**ZONING AMENDMENT,**  
**PLANNED UNIT DEVELOPMENT &**  
**SUBDIVISION STAFF REPORT**

**Date: February 1, 2007**

<b><u>NAME</u></b>	Reid Cummings
<b><u>SUBDIVISION NAME</u></b>	Snowden Place Subdivision
<b><u>LOCATION</u></b>	North side of Cottage Hill Road, 110'+ East Christopher Drive East.
<b><u>CITY COUNCIL DISTRICT</u></b>	District 6
<b><u>PRESENT ZONING</u></b>	R-1, Single-Family Residential District
<b><u>PROPOSED ZONING</u></b>	R-1, Single-Family Residential and R-3, Multiple-Family
<b><u>AREA OF PROPERTY</u></b>	16 Lots / 13.3 ± Acres (Subdivision site) 1 Lot / 9.0 ± Acres (PUD and Rezoning site)
<b><u>CONTEMPLATED USE</u></b>	<p>Subdivision to create 16 lots, Planned Unit Development Approval to allow a 36-unit condominium complex consisting of 9 buildings, a pool, and a two wooden piers on a single building site, and Rezoning from R-1, Single-Family Residential District, to R-3, Multiple-Family Residential District to allow a 36-unit condominium complex.</p> <p><b>It should be noted, however, that any use permitted in the proposed district would be allowed at this location if the zoning is changed. Furthermore, the Planning Commission may consider zoning classification

# SITE PLAN

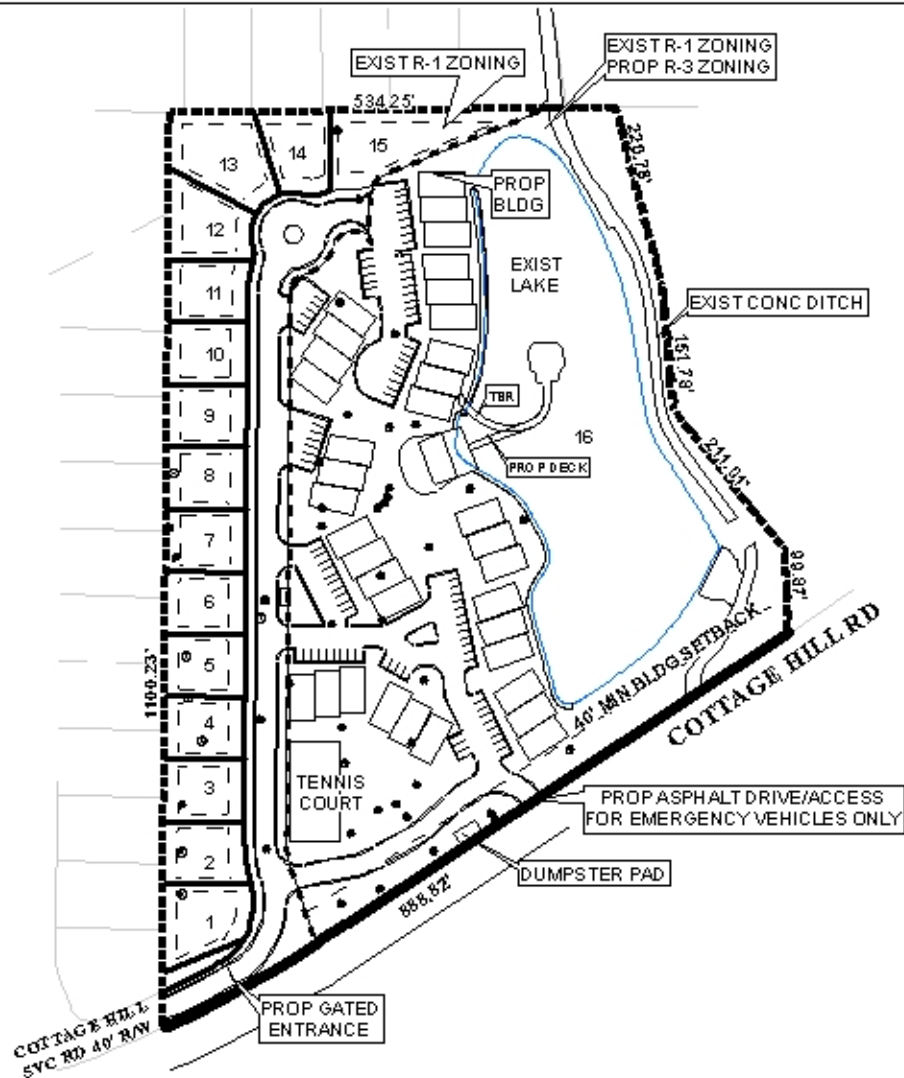
*A revised plat and site plan provided by the applicant depict changes in the layout of the subdivision and condominium development, and a reduction in the number of condominium units by one (35 instead of 36). The site plan also shows one additional access point for the site to Cottage Hill Road, reserved for emergency vehicles. The proposed street serving the development will be private and gated.*

*The single-family lots have been rearranged to provide more of a buffer between the proposed condominium development and the existing single-family residences North of the site. The condominiums are now a minimum of 60-feet from the nearest property line that abuts existing residential development.*

*Regarding the condominiums and the private street, units 24 and 32 are less than 10 feet from the private street “property line.” If the street were a public street, the buildings would normally be required to be a minimum of 25 feet from the edge of the right-of-way. It is recommended that the site plan be revised to ensure that each building is a minimum of 10 feet from the edge of the private street right-of-way. It should also be pointed out that unit 18 is less*

*than 10 feet from the requested 40-foot setback from Cottage Hill Road: the 40-foot setback is to allow for a future service road. It is recommended that unit 18 be set back an additional 10 feet, so that all buildings are a minimum of 50 feet from the Cottage Hill Road right-of-way. The depicted mail box unit should also be moved so that it is at least 10 feet from the private street right-of-way, and in fact it would be better located on an internal circulation street for Lot 16.*

*The last item of concern regards the proposed location of the dumpster, which is depicted within the 40-foot setback from Cottage Hill Road. Because of the purpose of the 40-foot setback, to allow space for a service road, the proposed dumpster should be removed from the setback area and located elsewhere within the proposed development, and should meet all minimum setback and screening requirements.*

**Rezoning:** Based upon the revised site plan, the rezoning request is recommended for Approval, subject to the following conditions: 1) revision of the legal description, if necessary, to reflect the revised boundary of the R-3 area; 2) provision of a minimum building setback line of 50 feet from the existing right-of-way of Cottage Hill Road; 3) completion of the Subdivision process; and 4) full compliance with all other municipal codes and ordinances.

**Planned Unit Development:** Based upon the revised site plan, the PUD request is recommended for Approval, subject to the following conditions: 1) revision of the legal description, if necessary, to reflect the boundary of the entire Subdivision site; 2) revision of the site plan to relocate the proposed dumpster pad from the 40-foot setback along Cottage Hill Road; 3) revision of the site plan to locate all condominium units a minimum of 10-feet from the edge of the private road right-of-way; 4) revision of the site plan to locate the mail box facility a minimum of 10-feet from the edge of the private road right-of-way, preferably so that access is from a street internal to Lot 16; 5) placement of a note on the site plan stating that the maximum building site coverage for Lots 1-15 is 35%, and for Lot 16 is 45%; 6) revision of Note 1 on the site plan regarding setbacks to state that the setbacks apply specifically to Lots 1-15; 7) provision of a note stating that the minimum building setbacks for Lot 16 are 50-feet from Cottage Hill Road, 10-feet from the private street, and 8-feet from all other property lines, and depiction of these setbacks on the site plan; 8) compliance with Engineering comments (*If the ditch takes public water, provide a drainage easement. If the lake is to be used for detention, the pond design should be submitted for the additional impervious area. The applicant is responsible for verifying if the site contains wetlands. The site can be checked against the National Wetlands Inventory on the COM web site Environmental Viewer. If the site is included on the NWI, it is the applicant's responsibility to confirm or deny the existence of regulatory wetlands. Must comply with all storm water and flood control ordinances. Any work performed in the right of way will require a right of way permit.*); 9) compliance with Urban Forestry comments (*Property to be developed in compliance with state and local laws that pertain to tree preservation and protection on both city and private properties (State Act 61-929 and City Code Chapters 57 and 64). Preservation status granted for all 50" and larger trees. All work under the canopies is to be permitted and coordinated with Urban Forestry, removal to be permitted by Urban Forestry only in the case of disease or impending danger. Exact curb cut locations and location of the proposed street and internal circulation drive should also be coordinated with*

**Subdivision:** Based upon the revised plat, the Subdivision request is recommended for Tentative Approval, subject to the following conditions: 1) placement of a note on the plat stating that Lots 1-15 are limited to one curb-cut each onto the proposed private street, that Lot 16 is limited to one emergency access only curb-cut onto Cottage Hill Road and six (6) curb-cuts onto the proposed private street, and that all curb-cuts are to be approved by Traffic Engineering and conform to AASHTO standards; 2) placement of a note on the plat stating that the maximum building site coverage for Lots 1-15 is 35%, and for Lot 16 is 45%, subject to the rezoning of Lot 16 to R-3; 3) revision of Note 1 on the plat regarding setbacks to state that the setbacks apply specifically to Lots 1-15; 4) provision of a note stating that the minimum building setbacks for Lot 16 are 40-feet from Cottage Hill Road, 10-feet from the private street, and 8-feet from all other property lines, and depiction of these setbacks on the plat; 5) compliance with Engineering comments (*If the ditch takes public water, provide a drainage easement. If the lake is to be used for detention, the pond design should be submitted for the additional impervious area. The applicant is responsible for verifying if the site contains wetlands. The site can be checked against the National Wetlands Inventory on the COM web site Environmental Viewer. If the site is included on the NWI, it is the applicant's responsibility to confirm or deny the existence of regulatory wetlands. Must comply with all storm water and flood control ordinances. Any work performed in the right of way will require a right of way permit.*); 6) compliance with Urban Forestry comments (*Property to be developed in compliance with state and local laws that pertain to tree preservation and protection on both city and private properties (State Act 61-929 and City Code Chapters 57 and 64). Preservation status granted for all 50" and larger trees. All work under the canopies is to be permitted and coordinated with Urban Forestry, removal to be permitted by Urban Forestry only in the case of disease or impending danger. Exact curb cut locations and location of the proposed street and internal circulation drive should also be coordinated with Urban Forestry to ensure that no trees 50" and larger are effected.*); 7) compliance with Section VIII. of the Subdivision Regulations, regarding the provision of a private street; 8) designation on the plat of utility easements acceptable to the appropriate provider of utility services within the subdivision; 9) placement of a note on the plat stating that the street is privately maintained and not dedicated to the public; 10) placement of a note on the plat stating that if the private street is not constructed and maintained to the appropriate City standard, and is ultimately dedicated for public use and maintenance, 100 percent of the cost of the improvements required to bring the street up to the prevailing standard shall be assessed to the property owners at the time the private street is dedicated, with the assessment running with the land to any subsequent property owners; 11) placement of a note on the plat stating that the gate must remain operational and in use as a condition of the continuation of private street status, and; 12) full compliance with all other municipal codes and ordinances.
